Addendum

Reconstruction to
Elm Street Elementary School
Phase 1

BID Addendum No. 2
to
Drawings and Project Manual

May 16, 2025

BA01B

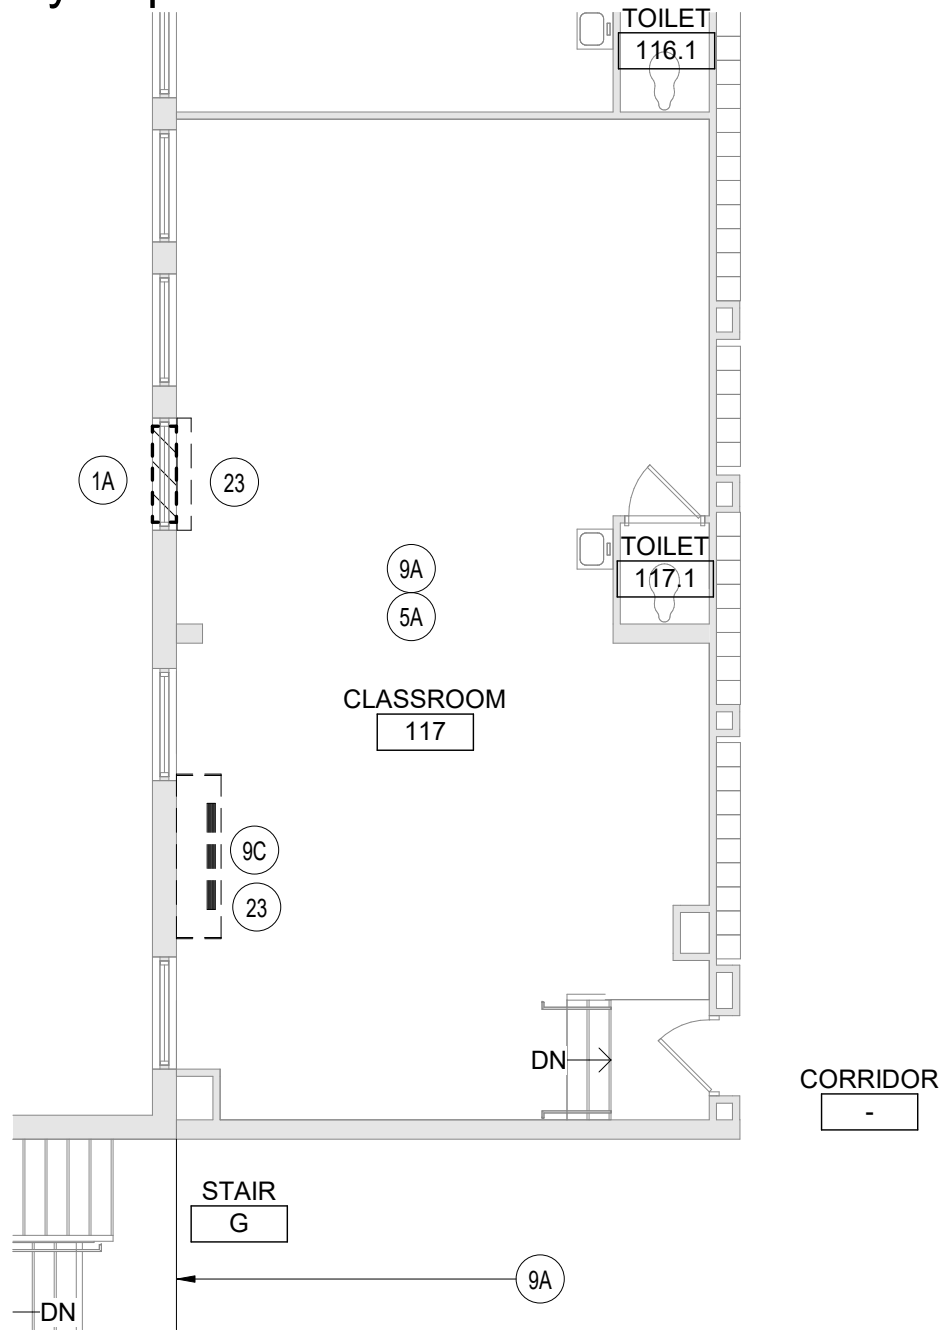
ITEM 2-C-3: Refer to DRAWING BA101

1. Detail 1, AMEND as shown on Drawing BA01B attached to this addendum.

BA02B

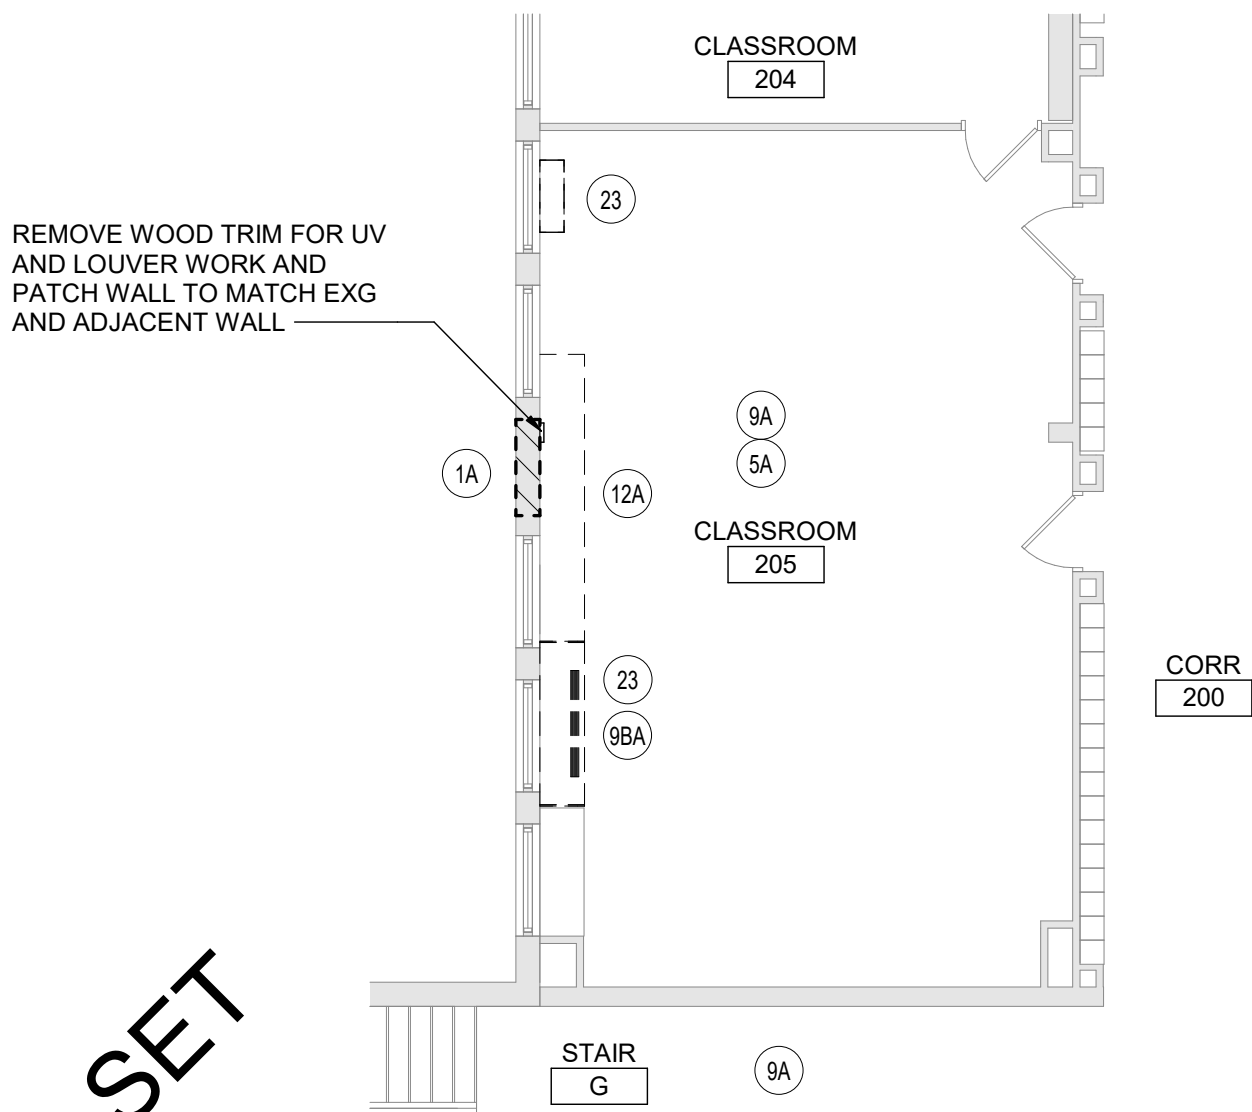
ITEM 2-C-4: Refer to DRAWING BA102

1. Detail 1, AMEND as shown on Drawing BA02B attached to this addendum.

BA03B

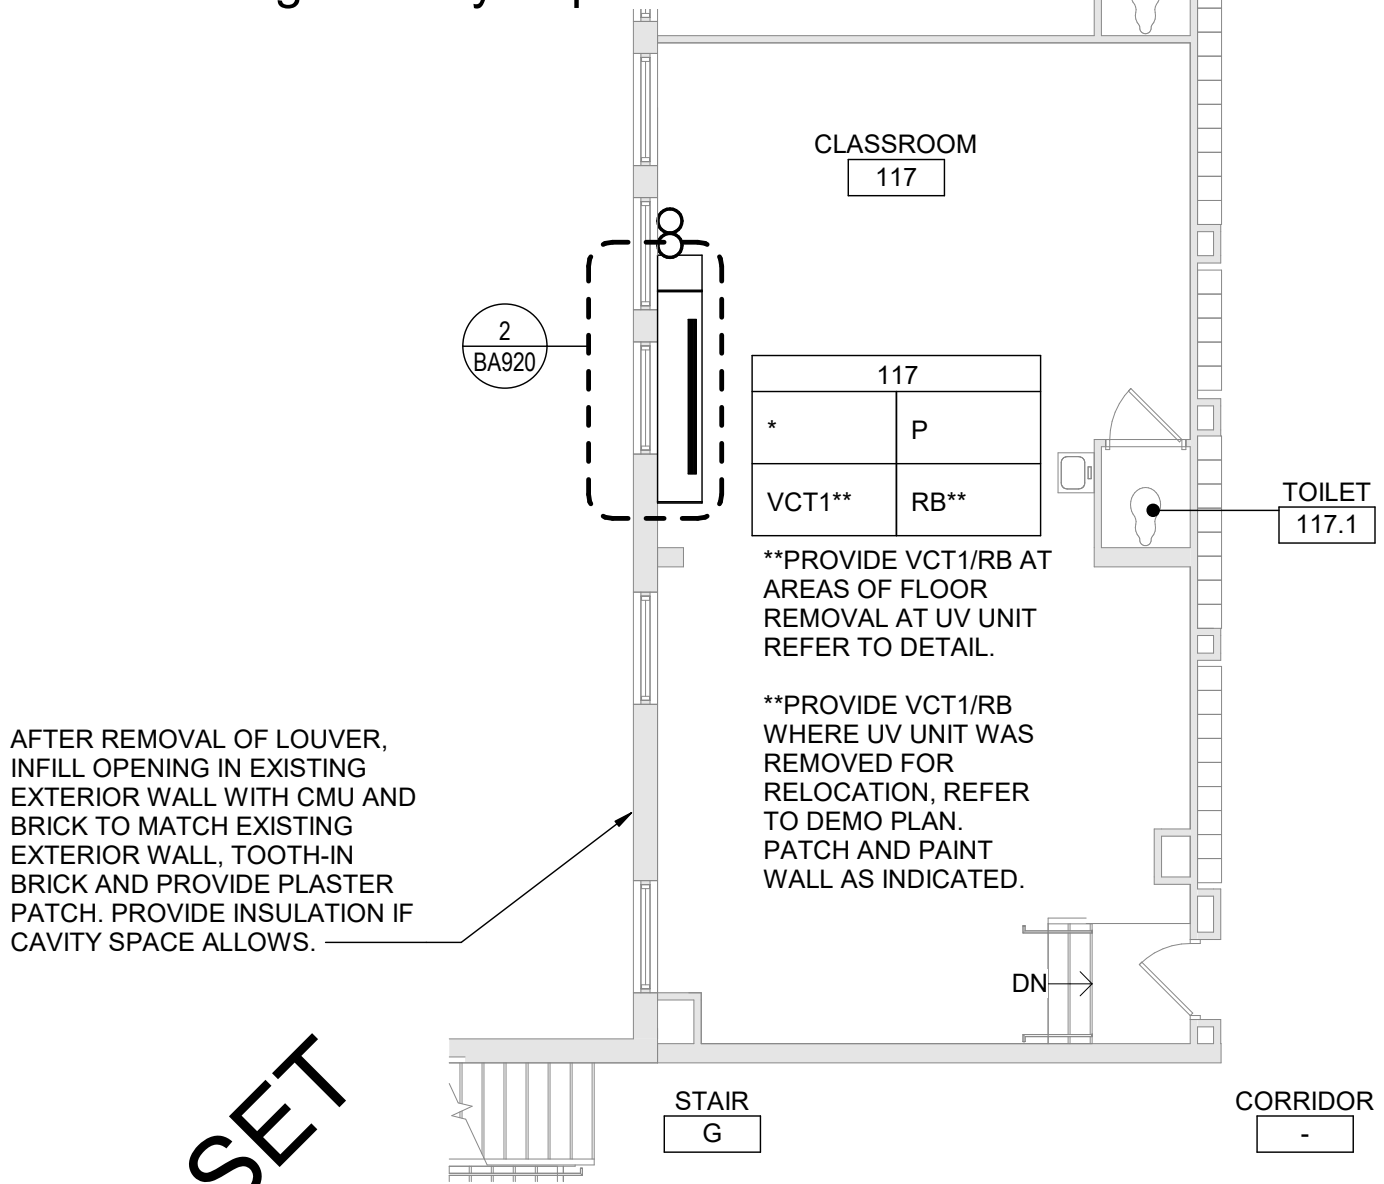
ITEM 2-C-5: Refer to DRAWING BA130

1. Detail 1, AMEND as shown on Drawing BA03B attached to this addendum.

2. Detail 1, at new UV louver openings in Rooms 117 and 121, ADD the following note:

“NEW LOUVER OPENING, SIZE TO BE 78 1/8” X 10 3/8” VERIFY FINAL SIZE WITH MECHANICAL CONTRACTOR AFTER SUBMITTALS ARE APPROVED AND FINAL EQUIPMENT SELECTIONS ARE MADE.”

BA04B

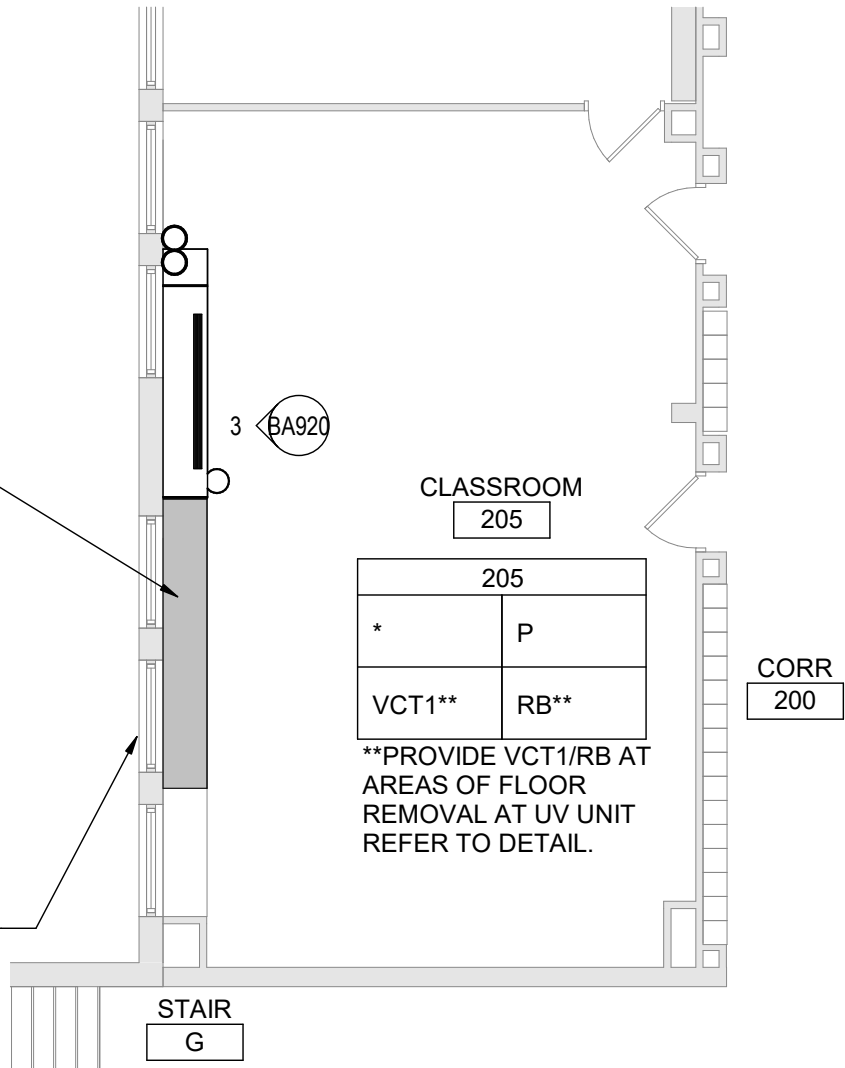
ITEM 2-C-6: Refer to DRAWING BA131

1. Detail 1, AMEND as shown on Drawing BA04B attached to this addendum.

2. Detail 1, at new UV louver opening in Room 205, ADD the following note:

3. Detail 1, at new PTAC louver openings in Rooms 203A and 203B, ADD the following note:

DEMO DWGS INDICATE TO CUT NEW LOUVER OPS IN EXTERIOR WALL
NEW PLAN DOES NOT INDICATE SAME
M DWGS ARE NOT CLEAR BUT APPEAR TO SHOW SLEEVE THRU WALL
ARE LOUVERS REQUIRED HERE? (2EA) WHAT SIZE?
(FOR FIGURING OPENING SIZE AND LINTELS)

“NEW LOUVER OPENING, SIZE TO BE 78 1/8” X 10 3/8”, COORDINATE FINAL SIZE WITH MECHANICAL CONTRACTOR AFTER SUBMITTALS ARE APPROVED AND FINAL EQUIPMENT SELECTIONS ARE MADE.”

“NEW LOUVER OPENING, SIZE TO BE 42” X 16 1/16”, COORDINATE FINAL SIZE WITH MECHANICAL CONTRACTOR AFTER SUBMITTALS ARE APPROVED AND FINAL EQUIPMENT SELECTIONS ARE MADE.”

BS01B

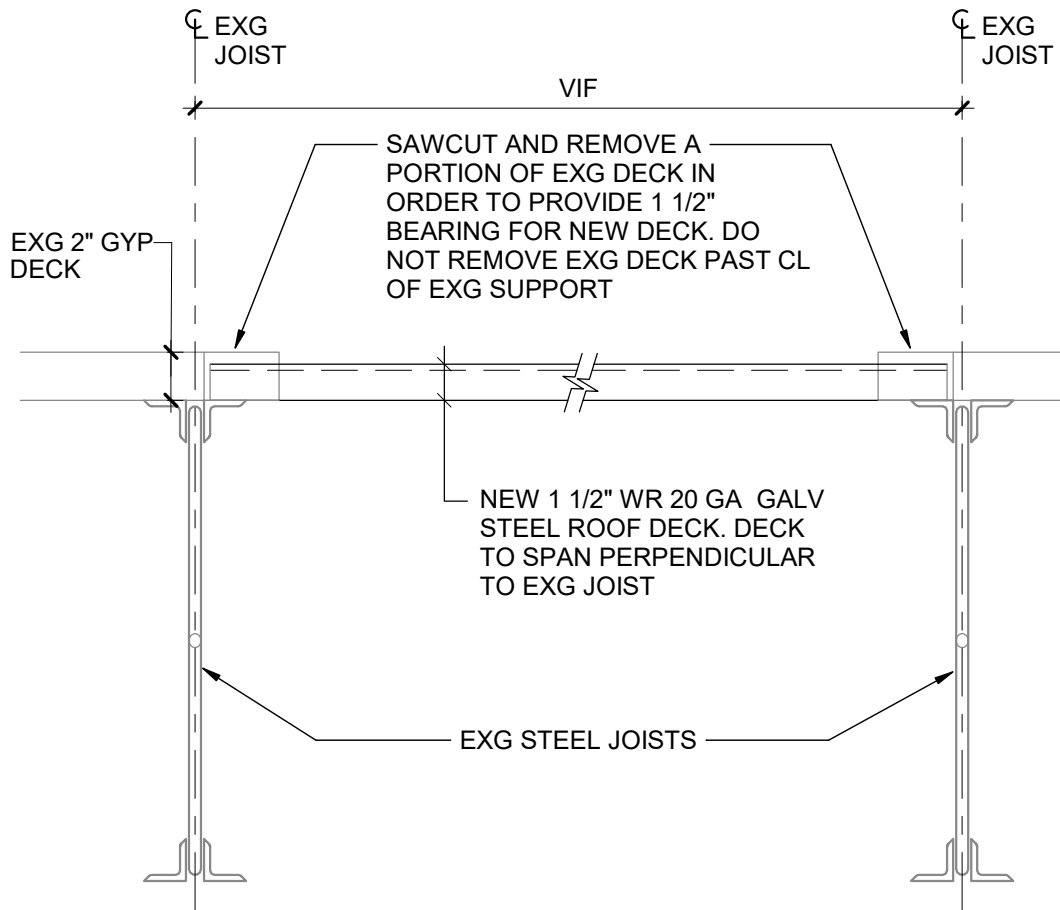
ITEM 2-C-7: Refer to DRAWING BS130

1. ADD Drawing BS01B attached to this addendum.

ROOF ABATEMENT DWG IS MISSING ACM ROOF CUTS @ RTH SIDE FOR RTH2 & RTH3.
A&S DWGS DO NOT DETAIL DECK INFILL AS NEEDED FOR MC RMVL OF TWO HOOD/CURBS AT N.E. CORNER OF 1938 SIDE —
IS CONCRETE NEEDED TO INFILL WITH DECK, OR IS PLYWOOD OK?

Refer to Bid Addendum 2 for BS01B typical deck infill detail.

BM01B

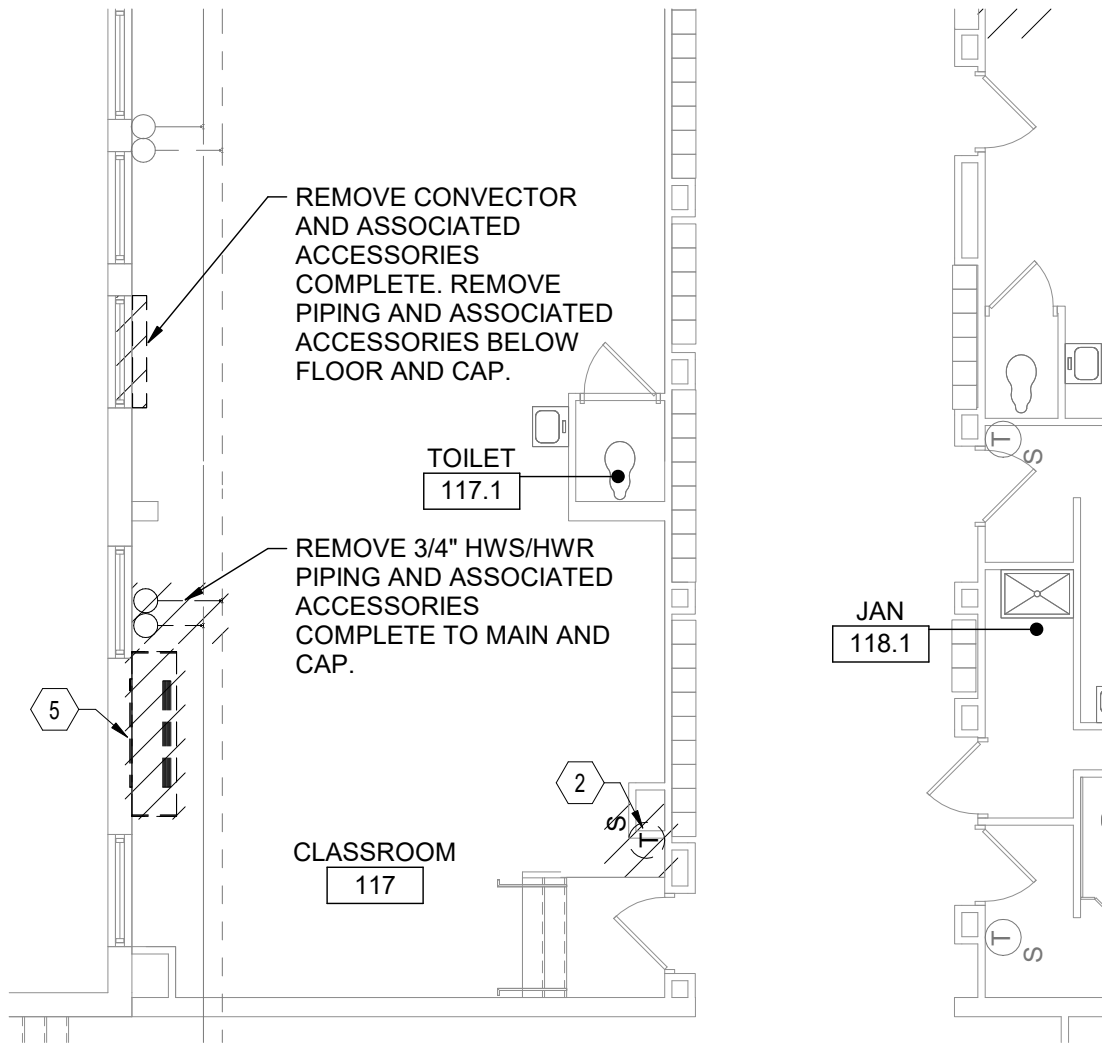
ITEM 2-C-8: Refer to DRAWING BM101

1. Detail 1, AMEND as shown on Drawing BM01B attached to this addendum.

BM02B

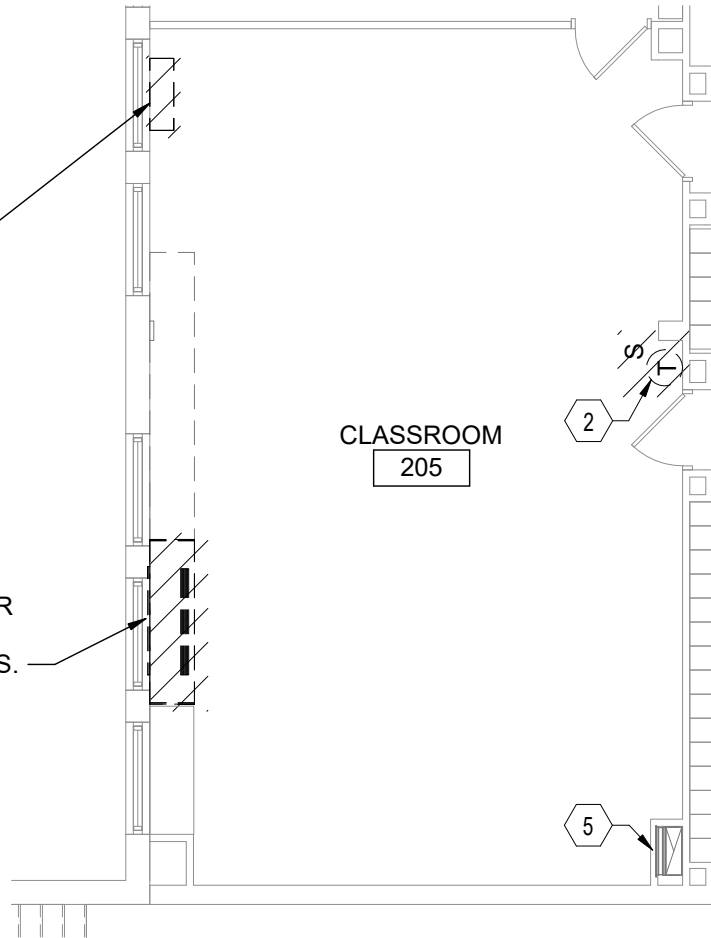
ITEM 2-C-9: Refer to DRAWING BM102

1. Detail 1, AMEND as shown on Drawing BM02B attached to this addendum.

BM04B

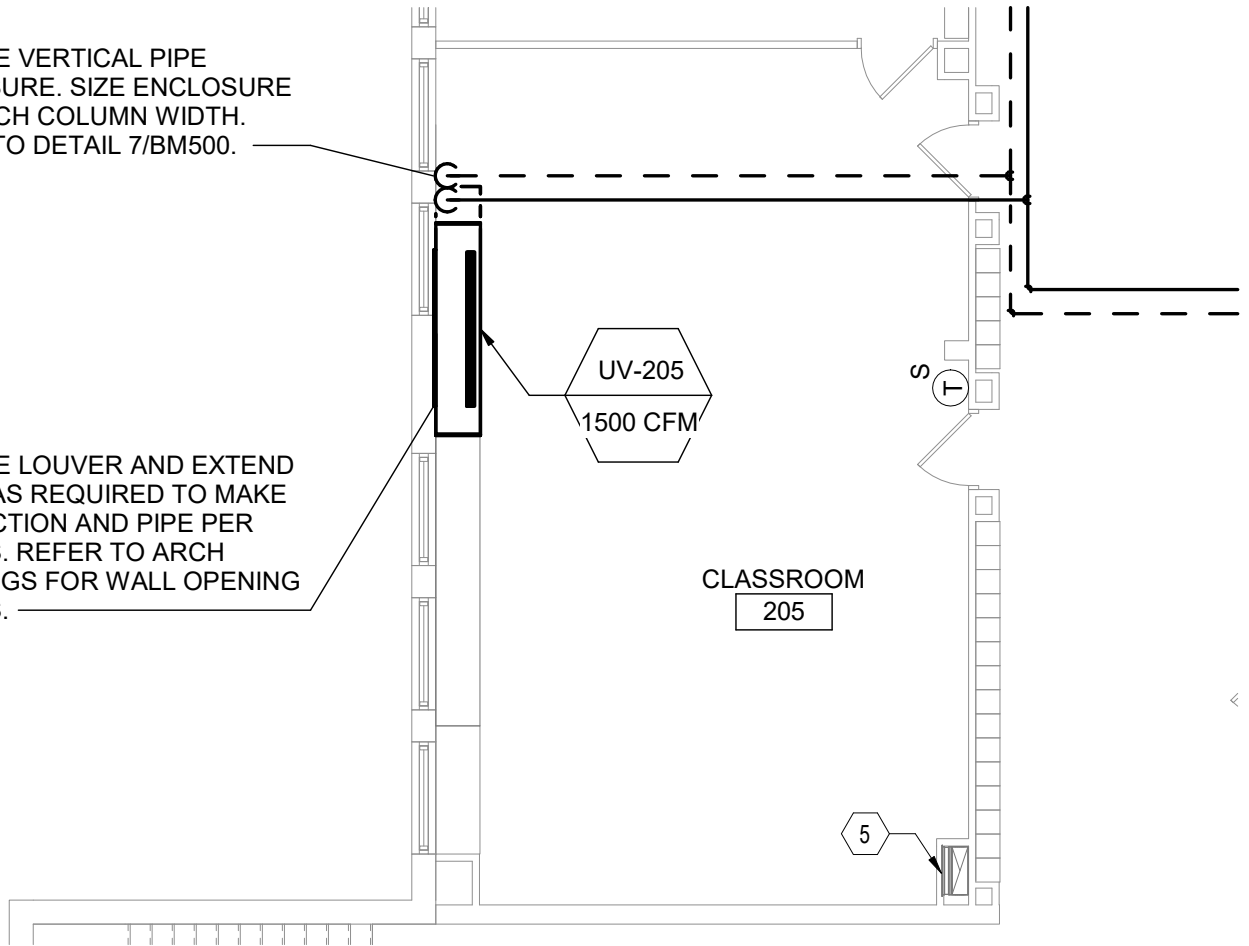
ITEM 2-C-11: Refer to DRAWING BM132

1. Detail 1, AMEND as shown on Drawing BM04B attached to this addendum.
